Product Change Notification: SYST-02PZSA903

dsPIC33EVXXXGM00X/10X Family Silicon Errata and Data Sheet Clarification

Revision X Document (6/2026)

Adds data sheet clarification 7 (10-Bit/12-Bit Analog-to-Digital Converter (ADC)) and 8 (Electrical Characteristics).

FIGURE 1:

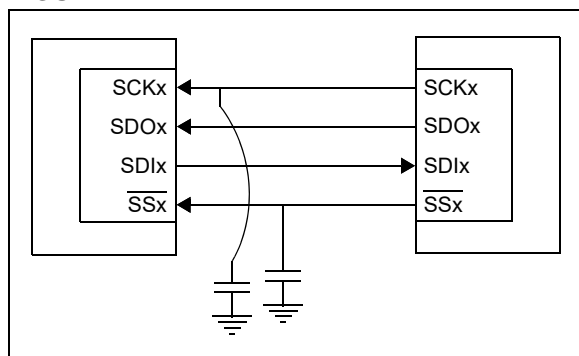
When the SPIx module is configured in SPIx Client mode (MSTEN bit (SPIxCON1[5]) = 0), the frame client (FRMEN bit (SPIxCON2[15]) = 1) and the SPIFSD bit (SPIxCON2[14] = 1), in Standard Buffer mode with the Clock Polarity Select bit, CKP = 0, the data are not transmitted in both 8-bit and 16-bit mode, but the data are being received correctly.

Adding a capacitance on the signal, as shown in Figure 1, will help the data to be received properly.

FIGURE 2: TIMING DIAGRAMS FOR CENTER-ALIGNED AND EDGE-ALIGNED MODES

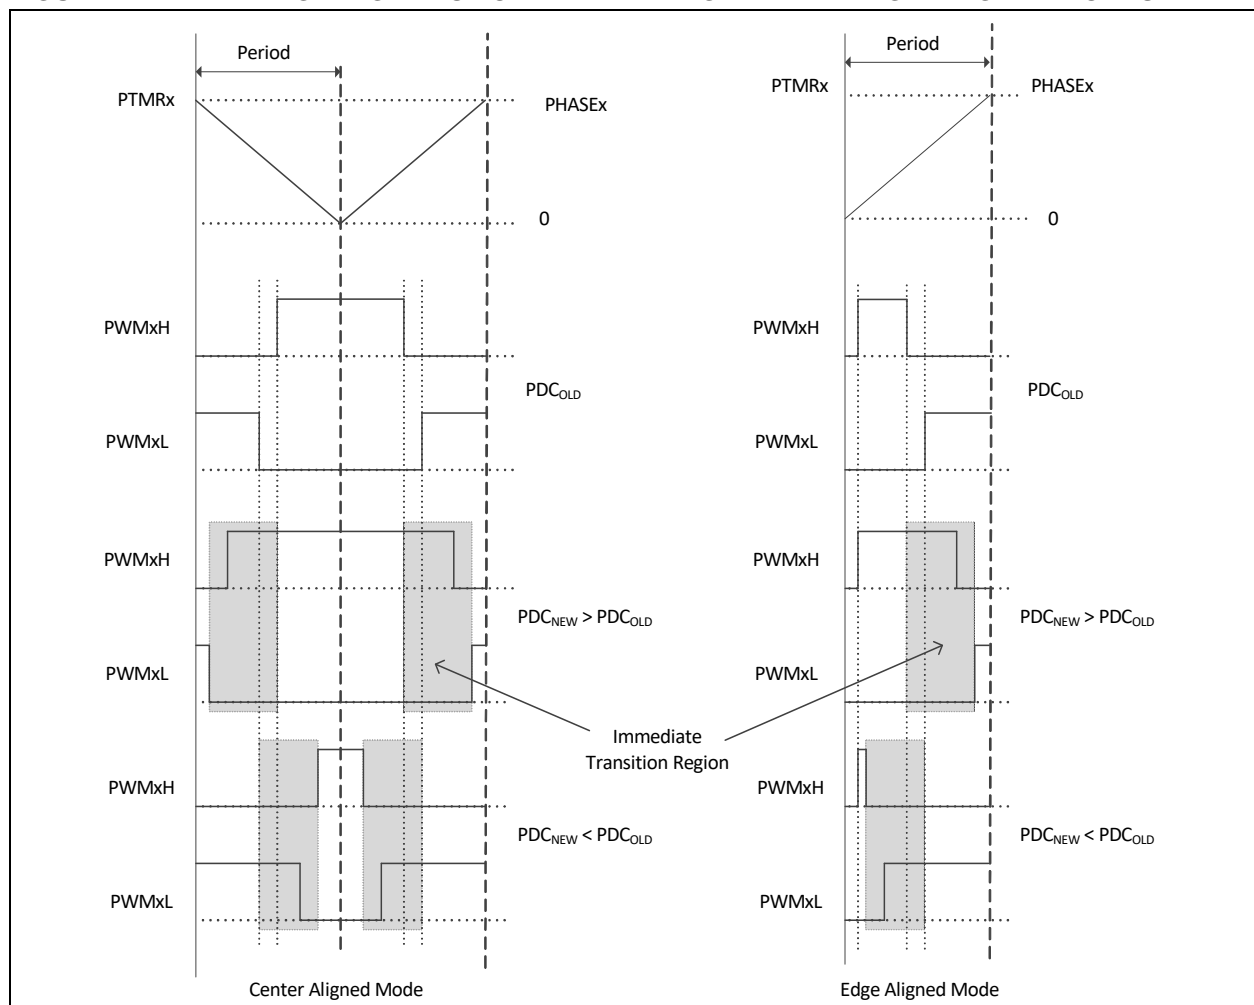
The PWM generator may not assert dead time on the edges of transitions. This has been observed when all of the following conditions are present:

In [Figure 2](#), if the duty cycle write occurred in the shaded box, then PWMxH and PWMxL will make an immediate transition without dead time.

However, in most applications, the duty cycle update timing can be controlled using the TRIGx trigger or Special Event Trigger, such that the above mentioned conditions are avoided altogether.

FIGURE 3: ILLUSTRATION OF 1 TOSC GLITCH WHEN PWM OVERRIDE IS TURNED OFF

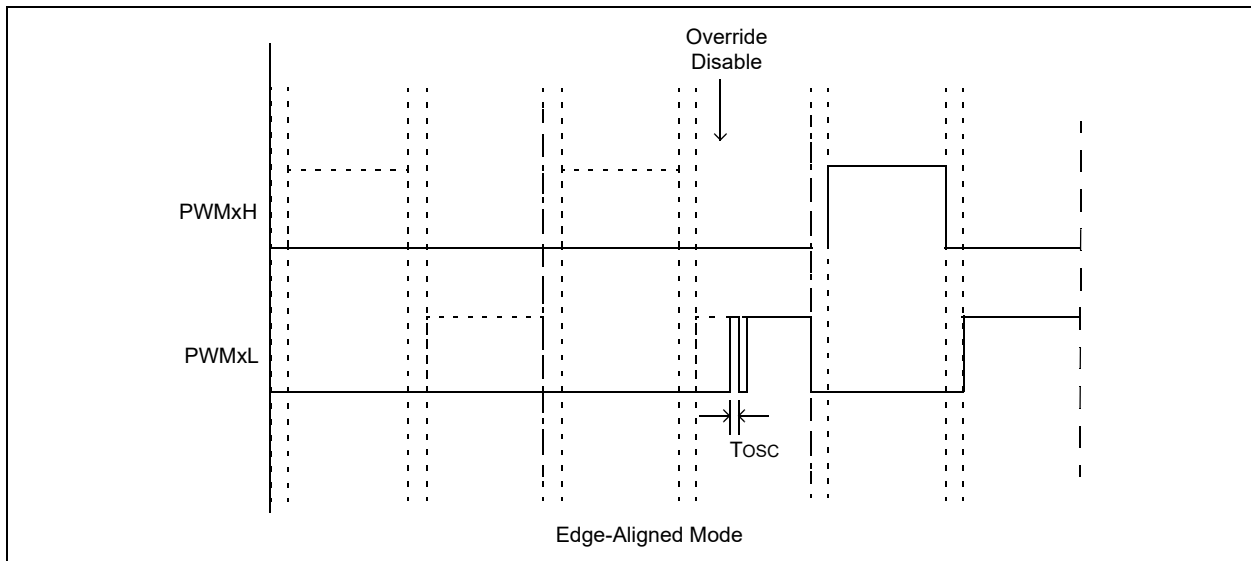
In Complementary mode after the PWM module is enabled ($PTEN = 1$), if the PWM override is turned off, a one TOSC glitch will be present on the rising edge of either the PWMxH or PWMxL pins, whichever occurs first, as shown in Figure 3.

FIGURE 4:

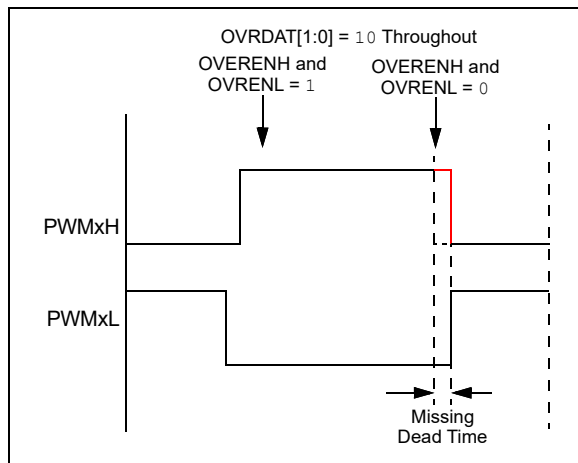
In Complementary Output mode, the expected dead time between transitions of the PWMxH and PWMxL outputs may not be asserted when the following occurs:

- Output override synchronization is configured to occur on the CPU clock boundary (IOCONx[0] = 0);
- Both PWMxH and PWMxL overrides are enabled prior to the event (OVRENH and OVRENL are both '1'), and
- Both overrides are disabled (OVRENH and OVRENL are both '0') at the instant the dead time should be asserted (Figure 4). This has been observed in both Center-Aligned and Edge-Aligned modes.

FIGURE 5:

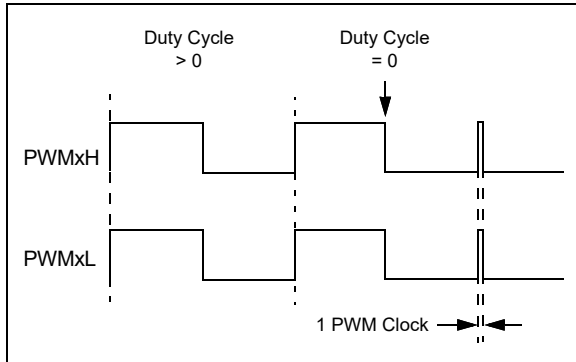
In the Redundant Output mode (IOCONx[11:10] = 10) and Push-Pull Output mode (IOCONx[11:10] = 01) with Immediate Update disabled (PWMCONx[0] = 0), when the Duty Cycle register is updated from a non-zero value to zero, a glitch pulse of a width equal to one PWM clock will appear at the next PWM period boundary, as shown in Figure 5, for the Redundant Output mode. Here, the Duty Cycle register refers to the PDCx register if PWMCONx[8] = 0 or the MDC register if PWMCONx[8] = 1.

FIGURE 7: SIMPLIFIED BEHAVIOR

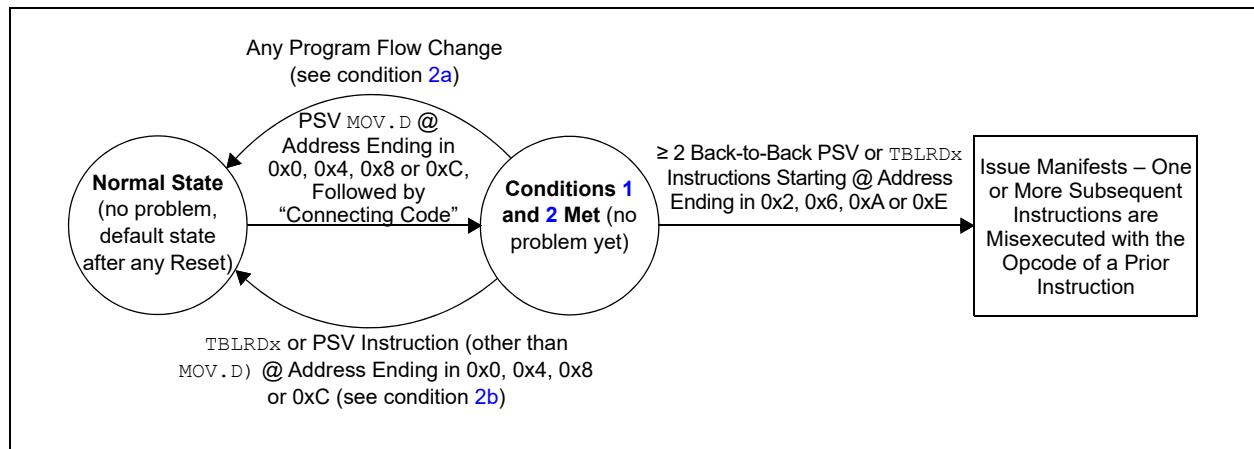
3.	≥ 2 back-to-back PSV or <code>TBLRDx</code> instructions are executed (following the code of condition 2), where the first of the back-to-back instructions is located at an address ending in 0x2, 0x6, 0xA or 0xE.

[Figure 7](#) provides an example of the effective behavior.

1. All instances of PSV MOV.D can be replaced with two PSV MOV instructions instead. Non-PSV MOV.D instructions acting on RAM/SFRs do not need to be modified; or
2. If not already present, a program flow change instruction (such as BRA \$+2) can be inserted above back-to-back data Flash read sequences; or
3. Back-to-back data Flash read instruction sequences can be broken up by inserting a non-Flash read instruction (such as a NOP), in between the Flash read instructions; or
4. The alignment of the code can be shifted to avoid the required opcode location addresses.

Figure 24-3. ADC Input Model

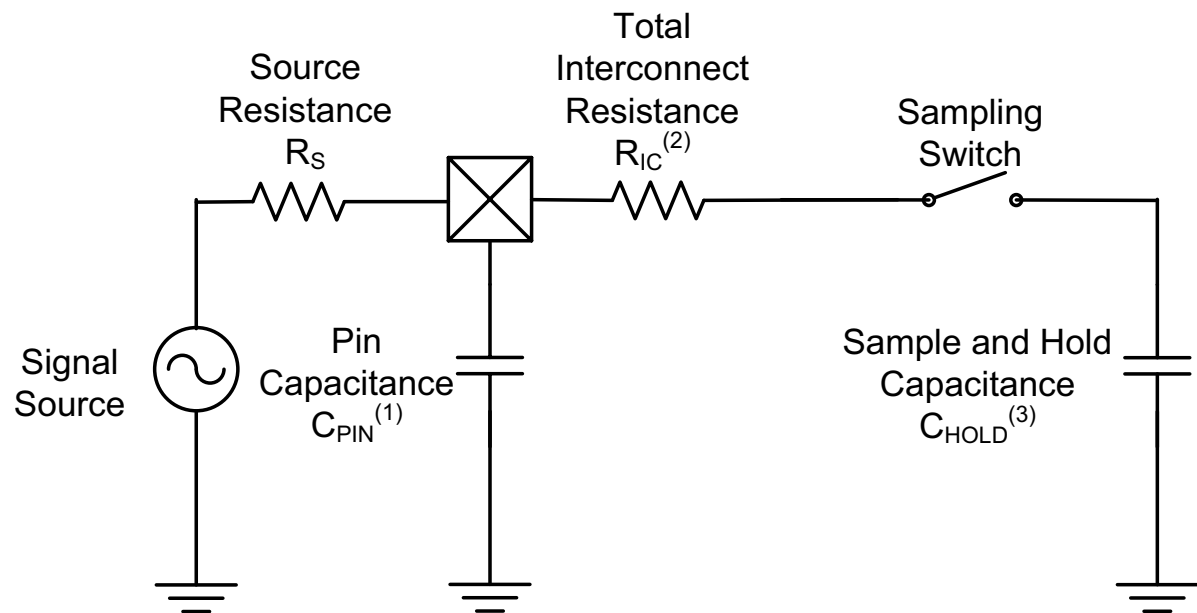
Section 24.1.3 Sampling Time Requirements is added as bellow:

The analog input model of the ADC is illustrated in Figure 24-3.

$$TSAMPLING = 9 \times RTOTAL \times CHOLD$$

Note 1: The C_{PIN} value depends on the device package and is not tested. For QFN or TQFP packages, the typical value is about 4 pF.
